RE: Majestic Phase 10 Bldg. 16 Subaru Library Time (#1445425) Response to Pre-App Meeting Comments

Enclosed you will find our submittal of the Planning Documents for the above referenced project. Below you will find our responses to the pre-app meeting comments in bold.

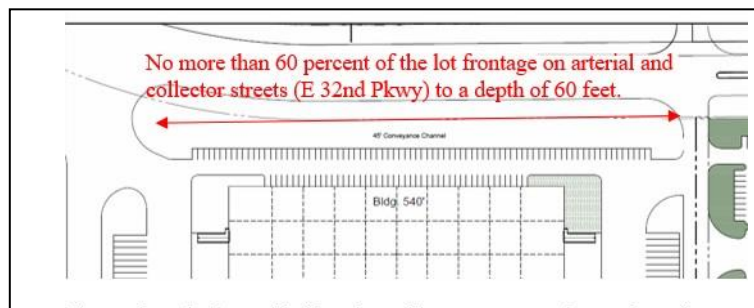
Per the Landscape Standards highlighted in the Master Plan, building entries shall be enhanced with landscaping, lighting, paving, furnishings, etc. The landscape shall be designed to create a sense of arrival, provide for pedestrian scale, and create a pedestrian space. The landscape will complement the architecture and provide for year-round seasonal interest. Please ensure the project provides adequate pedestrian access from E. 32nd Parkway to meet these standards.

The Site Plan shall conform to the Access and Connectivity standards highlighted in [Section 146](#). Please revise the plan so that access points align with neighboring vehicular connections as required by Section 146-4.5.4.A, Table 4.5-1. The proposed connection on the east side of the property currently does not align with the access point of the building east of the site. Show cross-access vehicular circulation between the proposed buildings. In addition, please show the complete alignment of the drive aisle along the west portion of the site. Indicate locations of cross-access with properties to the west, landscape medians, and curb and gutter. The north-south drive on the west needs to include a sidewalk connection from 32nd Parkway to the south end of the drive with sidewalk connections to building entrances and the internal sidewalk network on the site. The sidewalk along the drive should be 5.5-foot wide and detached from the curb, with landscaping and trees between the sidewalk and curb.

Response: Understood.

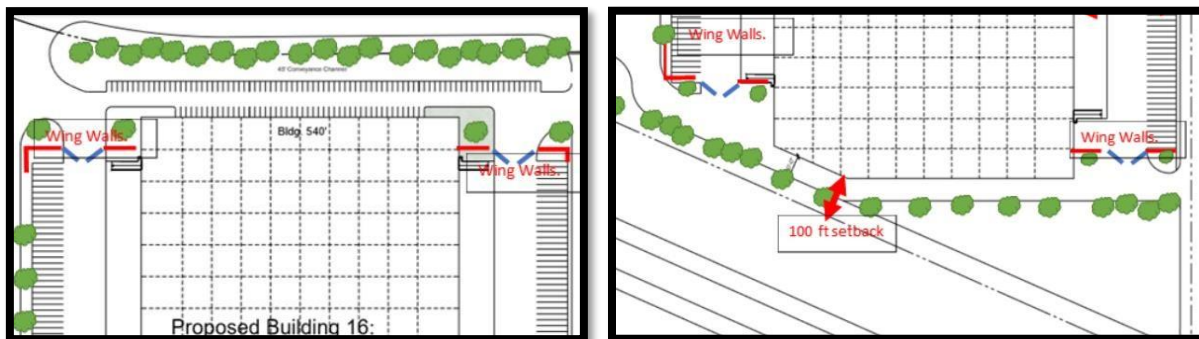
Below are both building design standards from both the Majestic Commercenter Master Plan (FDP) and UDO the proposed development shall follow:

- Building Orientation, Forms and Massing
 - Inclusion of entry/pedestrian plazas coordinated with the landscaping (FDP)
 - Main pedestrian entry, orients onto and provides direct pedestrian access onto a public street, plaza, courtyard, or pedestrian passage. (UDO)
 - Buildings shall incorporate primary entries to either primary and/or secondary building faces by using one of the methods shown in Table 4.8-9. (UDO)
 - Increased glazing areas and/or special glazing treatments at entry. (FDP)
 - Wrapping the glazing at corner walls should be used to accentuate entries. (FDP)
 - Buildings should be bold, clean, simple geometric forms with coordinated massing. (FDP)
 - Utilize at least one of the horizontal articulation methods shown in Section 146-4.8.5.B, Table 4.8-3 at an interval of 100 feet or less on each street facing façade of the primary building. (UDO)

- At least one of the following vertical articulation options shall be used for each of the three vertical element categories shown in Table 4.8-4. (UDO)

- Single walls exceeding 50 feet in length shall incorporate one or more of the listed features shown on Sheet 11 of the FDP for every 50 feet in length (FDP)

Response: Understood.
